UNITED STATES  
NUCLEAR REGULATORY COMMISSION  
WASHINGTON, D. C. 20555

LICENSEE: Carolina Power & Light Company  
FACILITY: Brunswick Steam Electric Plant, Units 1 and 2  
SUBJECT: SUMMARY OF MEETING HELD TO DISCUSS POSSIBLE CONCERNS WITH THE  
BRUNSWICK STEAM ELECTRIC PLANT, UNITS 1 AND 2, CONTROL BUILDING  
EMERGENCY AIR FILTRATION SYSTEM CHLORINE DETECTION LOGIC

**BRUNSWICK NUCLEAR PLANT  
CBHVAC SINGLE FAILURE CONCERNS**

# CONTROL BUILDING EMERGENCY AIR FILTRATION SYSTEM EXISTING CONFIGURATION

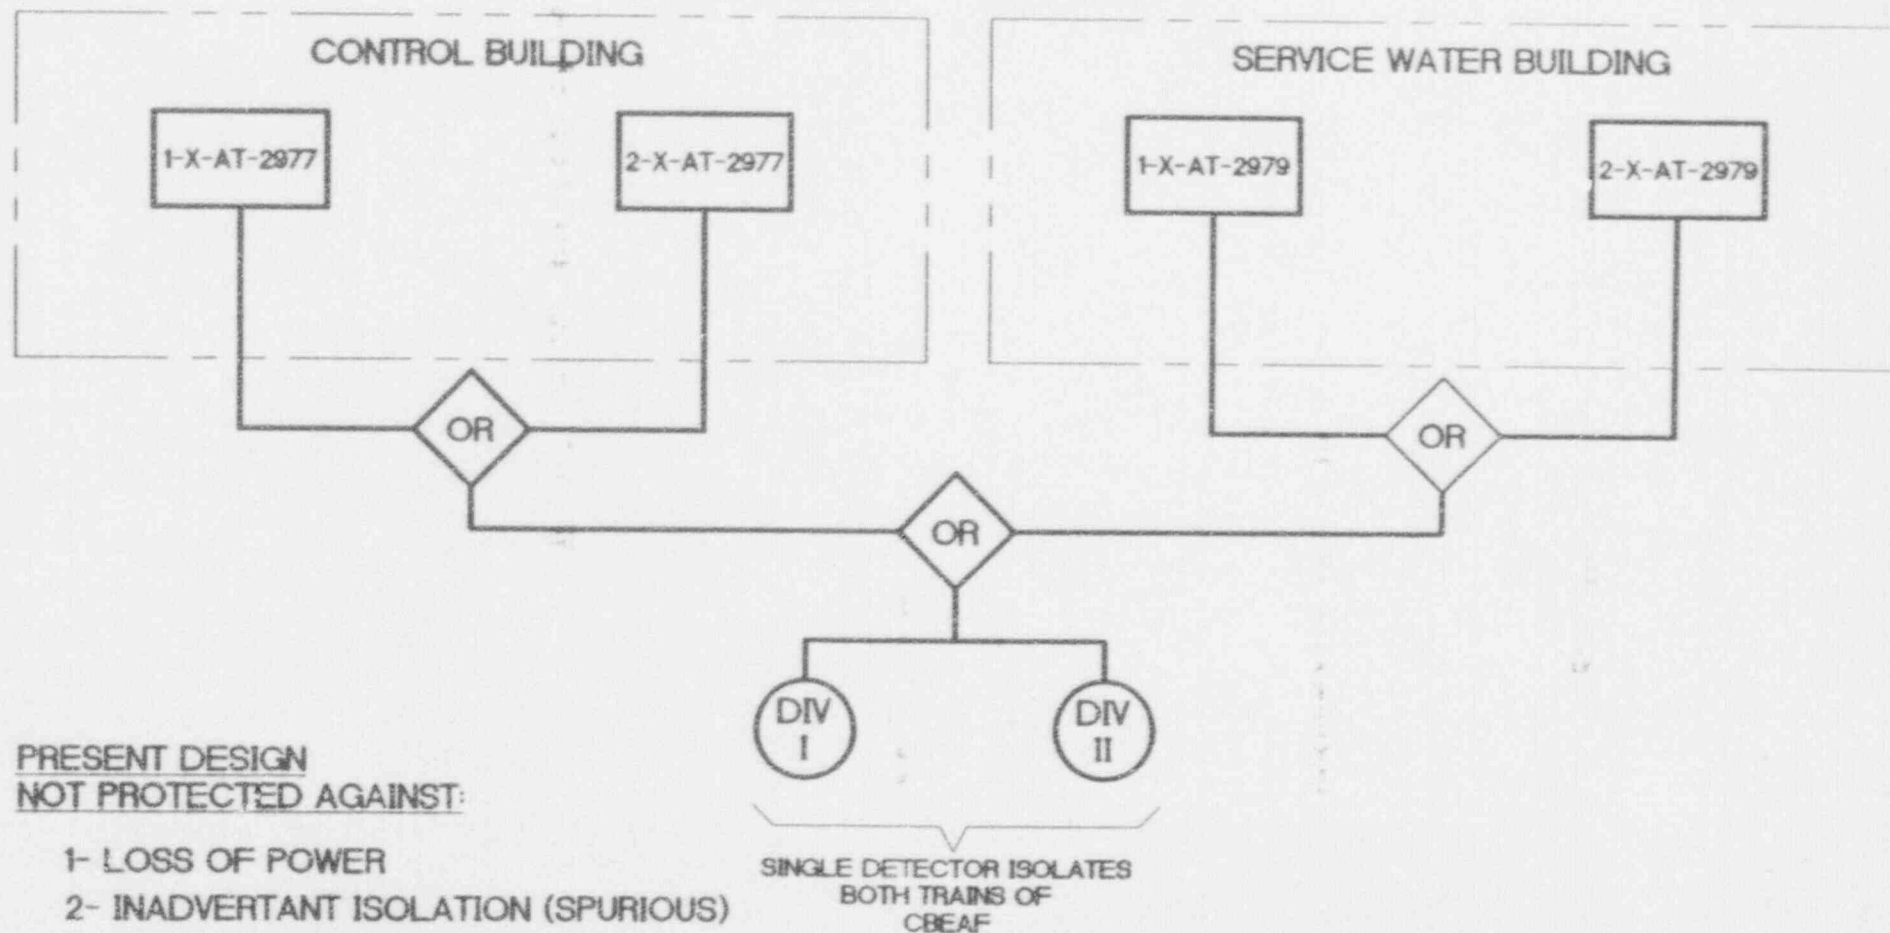
PRESENT DESIGN  
NOT PROTECTED AGAINST:

- 1- LOSS OF POWER
- 2- INADVERTANT ISOLATION (SPURIOUS)
- 3- SINGLE COMPONENT FAILURE

# CONTROL BUILDING EMERGENCY AIR FILTRATION SYSTEM PROPOSED CHANGE

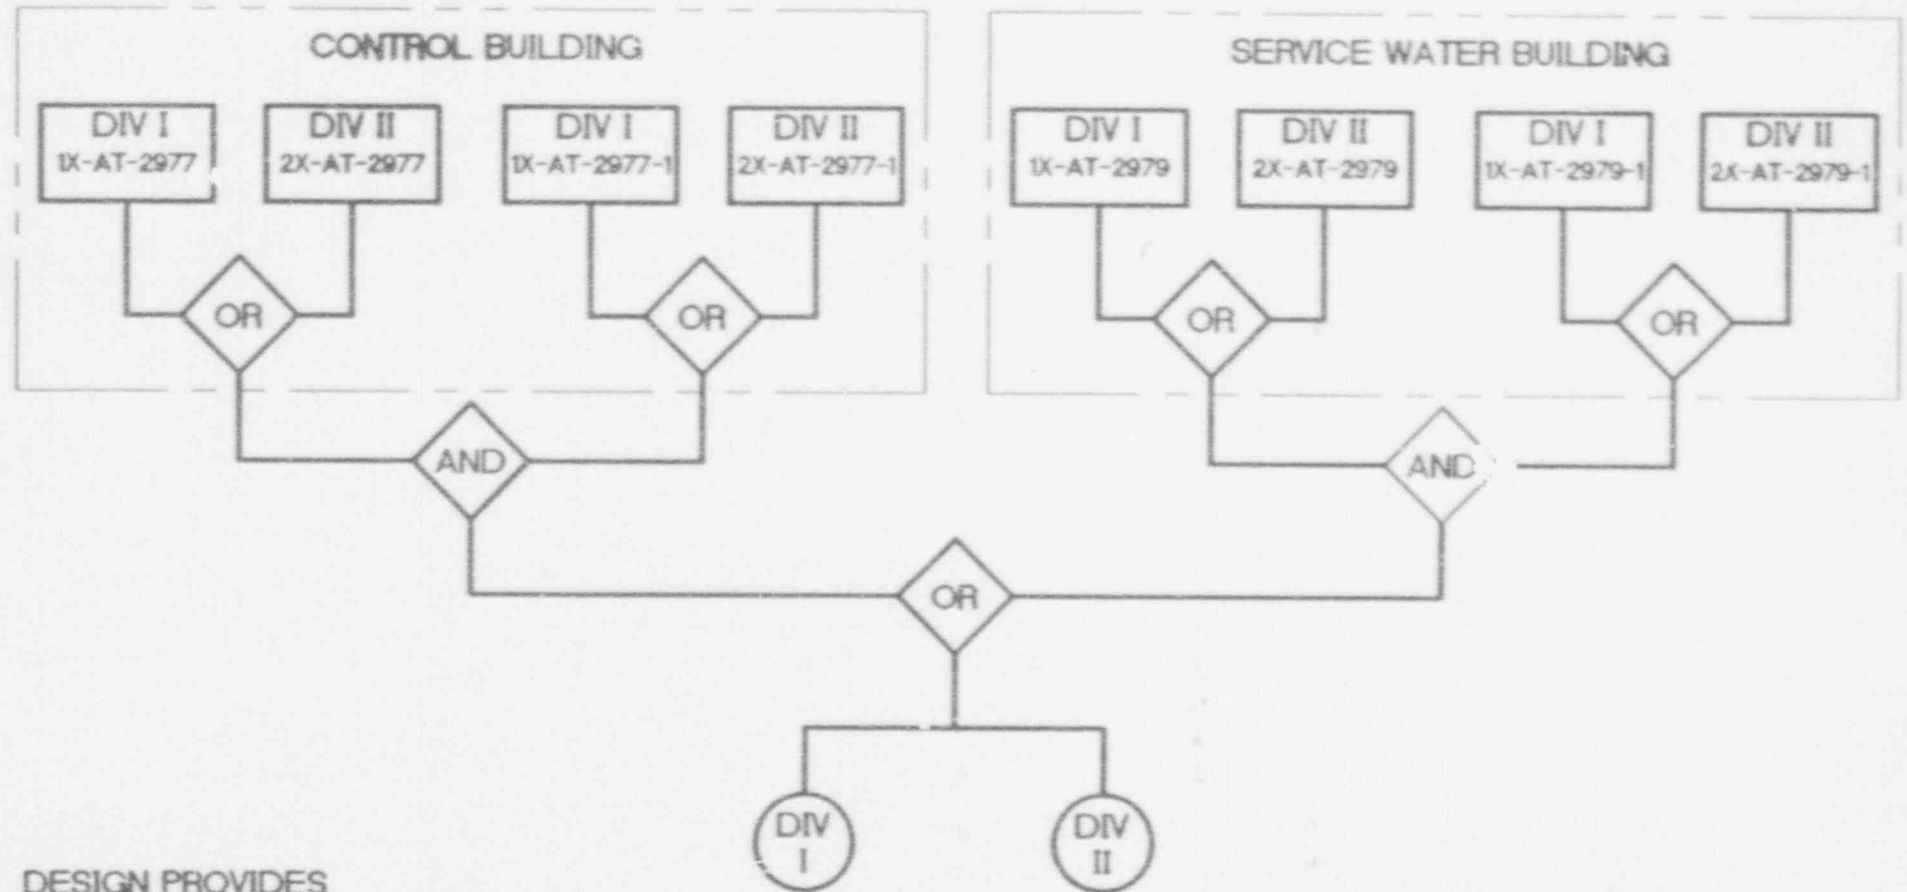
DESIGN PROVIDES  
PROTECTION AGAINST:

- 1- LOSS OF DIVISIONAL POWER
- 2- INADVERTANT ISOLATION (SPURIOUS)
- 3- SINGLE COMPONENT FAILURE
- 4- FAILURE TO DETECT CL<sub>2</sub>

EACH ISOLATES  
BOTH TRAINS OF  
CBEAF
